T.I. no.: 2016 - 07 Updated: -	Topic: Best Foam™ hardware adjustments
---	---

Date: 15/07/2016
Affected machines: SCA P Best Foam™
From serial number: 1607-xxxxxx
As of date: -

PROPORTIONAL VALVE PLACEMENT

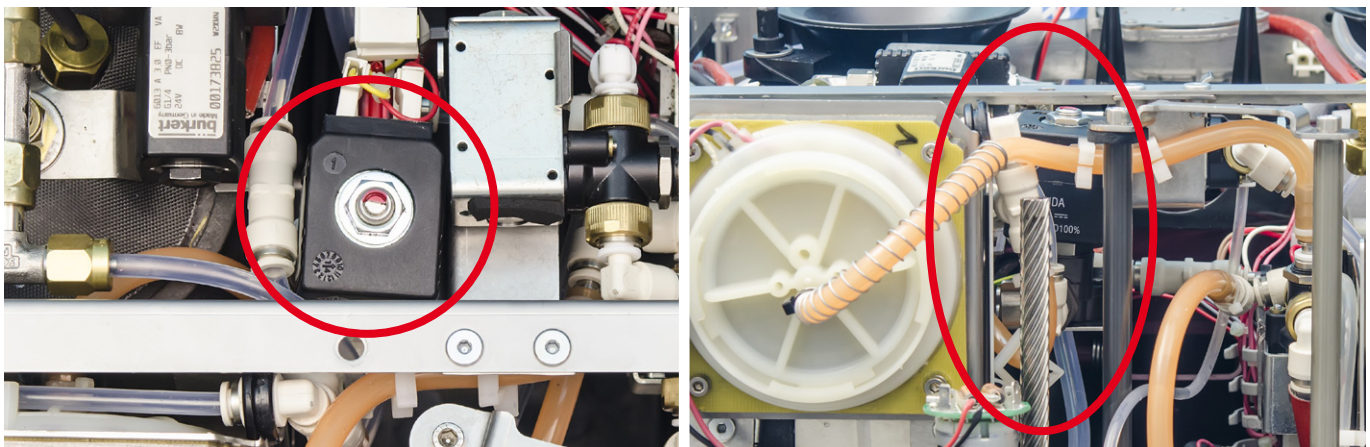
The placement of the proportional valve has been changed from horizontal to vertical to prevent deposits from forming. The original position caused increased deposits in the valve when water hardness was high (>10° dKH). These deposits can lead to fluctuations in temperature. Deposits are prevented by vertical placement.

This change is recommended for machines which are exposed to highly calcified water (>10° dKH).

NON-RETURN VALVE IN AIR PATHWAY

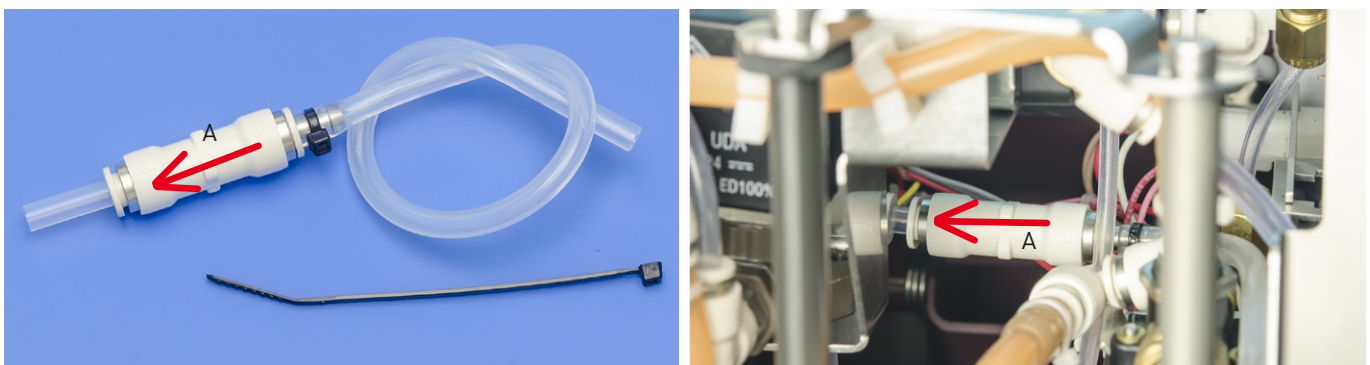
A non-return valve is installed in the air pathway to prevent humidity in the air pump.

This change is recommended. Kit 073'720 can be obtained from Schaeerer AG for free until 30/9/2016.
